## AMENDMENT ACKNOWLEDGMENT

AMENDMENT NO.2

DPP Project No.: 13-21-4643-01

Description: Engine 72 Decontamination Suite

- A. Contract Drawing MPE 1.3 Specification Section 16721 Item #3.

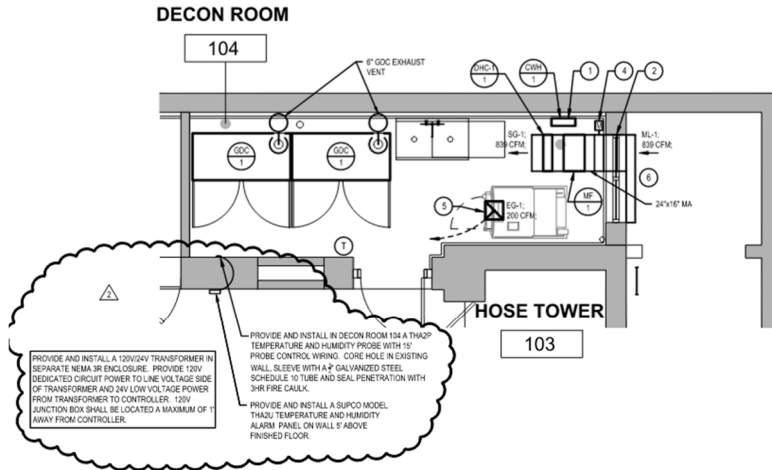
Remove the following paragraph in its entirety:

3. NEW MODULES AND PERIPHERAL DEVICES SHALL BE BY THE SAME MANUFACTURER AS THE EXISTING SYSTEM, AND SHALL BE SUPPLIED THROUGH ONE OF THEIR AUTHORIZED DISTRIBUTORS. PROVIDE ALL NECESSARY MODIFICATIONS TO THE HEAD-END EQUIPMENT, INCLUDING POWER EXTENDER PANELS FOR SUPPORTING ADDITIONAL AUDIBLE/VISUAL APPLIANCES.

Replace it with the following:

3. NEW MODULES AND PERIPHERAL DEVICES SHALL BE BY THE SERVICING INSTALLER (FORTRESS PROTECTION 215-854-8400) AND SHALL BE RATED WITH AND COMPATIBLE TO THE EXISTING HONEYWELL S3 SERIES FIRE ALARM CONTROL PANEL. FORTRESS PROTECTION SHALL BE RETAINED BY THE CONTRACTOR TO PROVIDE ALL NECESSARY MODIFICATIONS TO THE HEAD-END EQUIPMENT, INCLUDING POWER EXTENDER PANELS FOR SUPPORTING ADDITIONAL AUDIBLE/VISUAL APPLIANCES.

**1**  
**ML.2**  
**PARTIAL FIRST FLOOR PLAN**  
**MECHANICAL NEW WORK**  
SCALE : 1/4" = 1'-0"

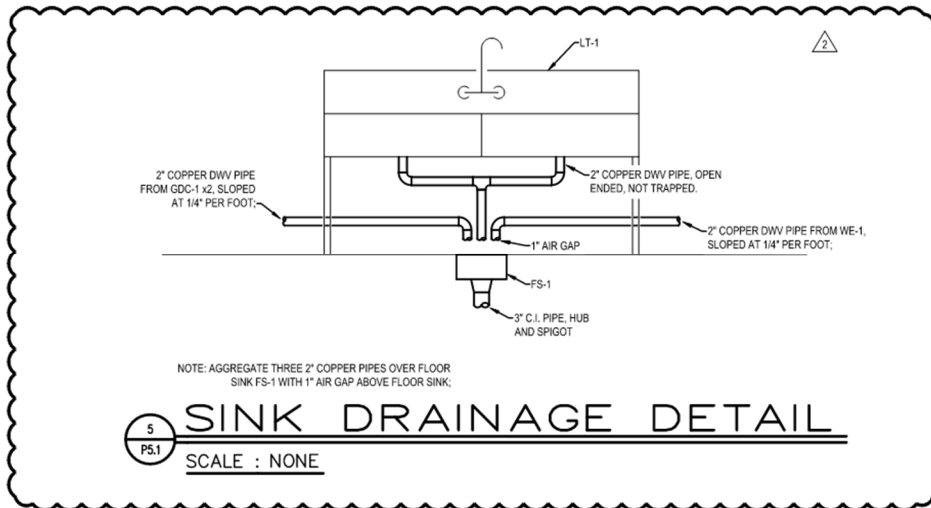
- A. Contract Drawing M1.2:

Provide the added sensor information to existing Detail #1. The provision

and installation of this sensor is a contract requirement:
